**REZONING,
PLANNED UNIT DEVELOPMENT
& SUBDIVISION STAFF REPORT**

Date: March 20, 2008

Graf Dairy Subdivision

Rezoning to B-2, Neighborhood Business, to allow a drug store, bank, and other unspecified commercial uses, and Rezoning to R-3, Multi-Family Residential, to allow a 76-unit residential condominium complex; Planned Unit Development Approval to allow multiple buildings on a single building site (condominium site), shared access between two building sites; and Subdivision approval to create 4 lots from a large metes and bounds parcel and individual lots of record.

SITE PLAN

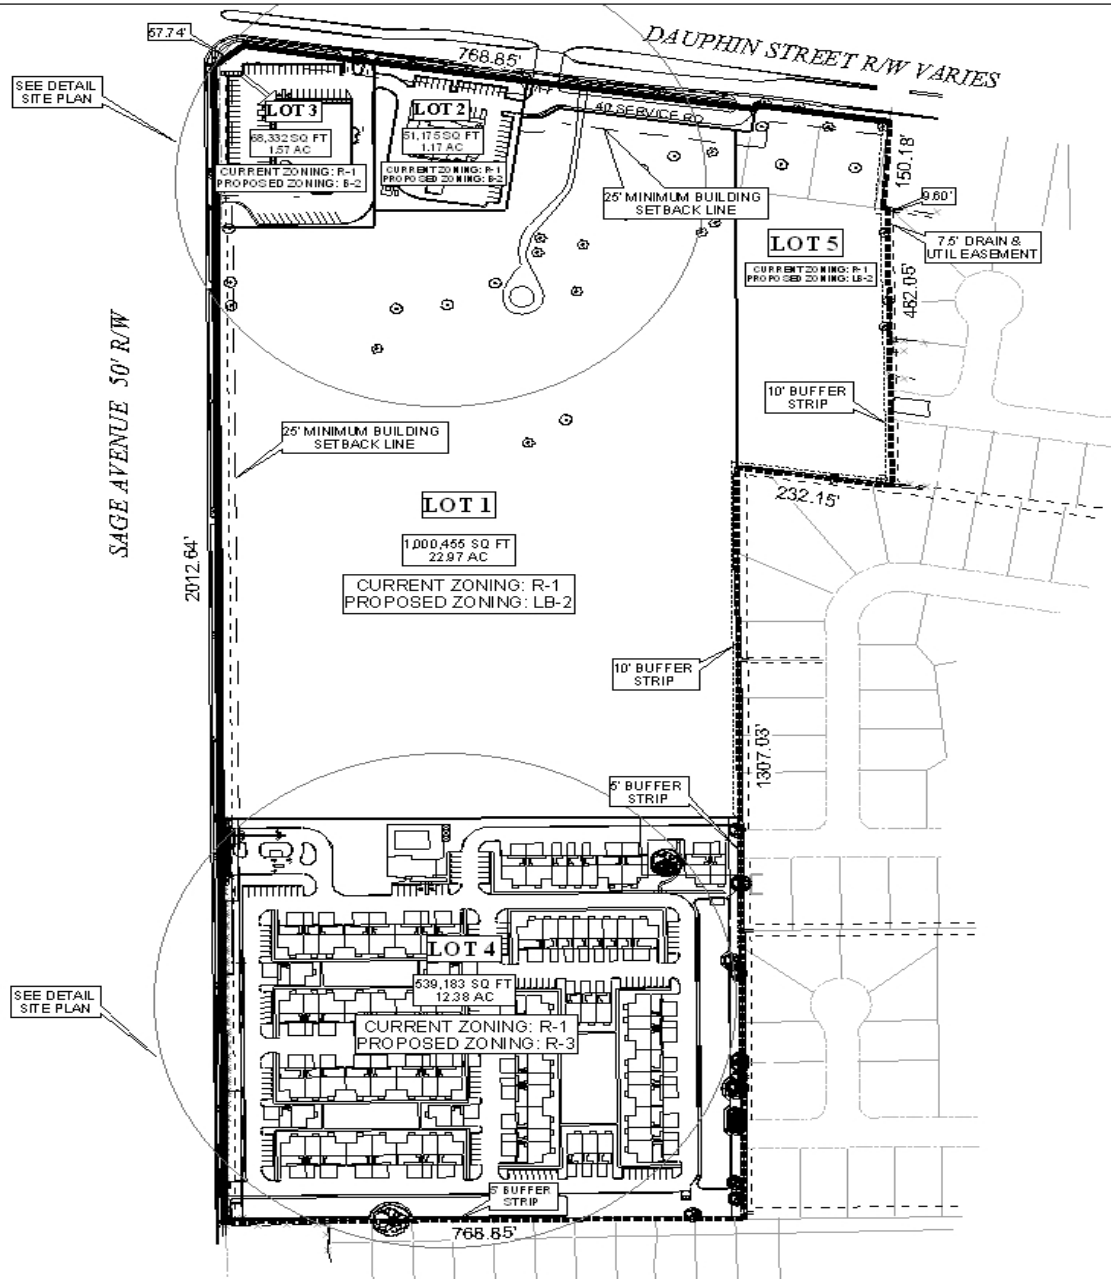
A sidewalk along Dauphin Street will be required as part of the development, if approved, as will any necessary repairs to the sidewalk along Sage Avenue (or construction of new if dedication and/or roadway improvements are required). The site plan should be revised to show both sidewalks.

The plan illustrates a buffer strip (ranging from 5' to 10') along the South and East property lines, where the site abuts residential properties.

While the proposed commercial developments at the corner of Dauphin Street and Sage Avenue remain as originally submitted, there have been some modifications to the layout of the condominium development proposed for Lot 4. The buildings have been reconfigured to create "quads" or common areas between several of the buildings. The plan also shows what appear to be covered and uncovered parking spaces in front of each unit; however, there are no labels, tags or legend to define exactly what is what.

Additionally, the access has been modified to a boulevard style entrance with a turn lane from Sage Avenue. Based on the plan submitted, it is difficult to determine if right-of-way for the proposed turn lane is to be dedicated, or if the turn lane is to be built within private property (as well as the sidewalk along Sage Avenue). Additionally, there had been discussion that access to the condominium development was to be gated. The plan submitted does not illustrate the location of any such gate (except at the emergency access point on the South end of the property).

- 3. provision of a natural buffer with a 6' high wooden privacy fence along the entire East property line, as shown on the plan submitted;*
- 4. Compliance with Fire Department Comments (must comply with the requirements of the 2003 International Fire Code, including Appendices B through D, as adopted by the City of Mobile, and the 2003 International Existing Building Code, as appropriate. Fire hydrants shall comply with Section 508.5.1 of the 2003 IFC. Dead ends shall comply with Table D105.1 of the 2003 IFC);*

7. *approval of gate locations for ingress/egress to Lot 4;*
8. *verification of spacing requirements for buildings on Lot4 (to be noted on the site plan)*

9. *verification/notation of parking spaces adjacent to the front of each condominium unit;*
10. *construction and repairs of sidewalks along Dauphin Street and Sage Avenue as necessary;*

11. *full compliance with all municipal codes and ordinances; and*
12. *submission of a revised site plan reflecting these conditions prior to the issuance of any permits.*
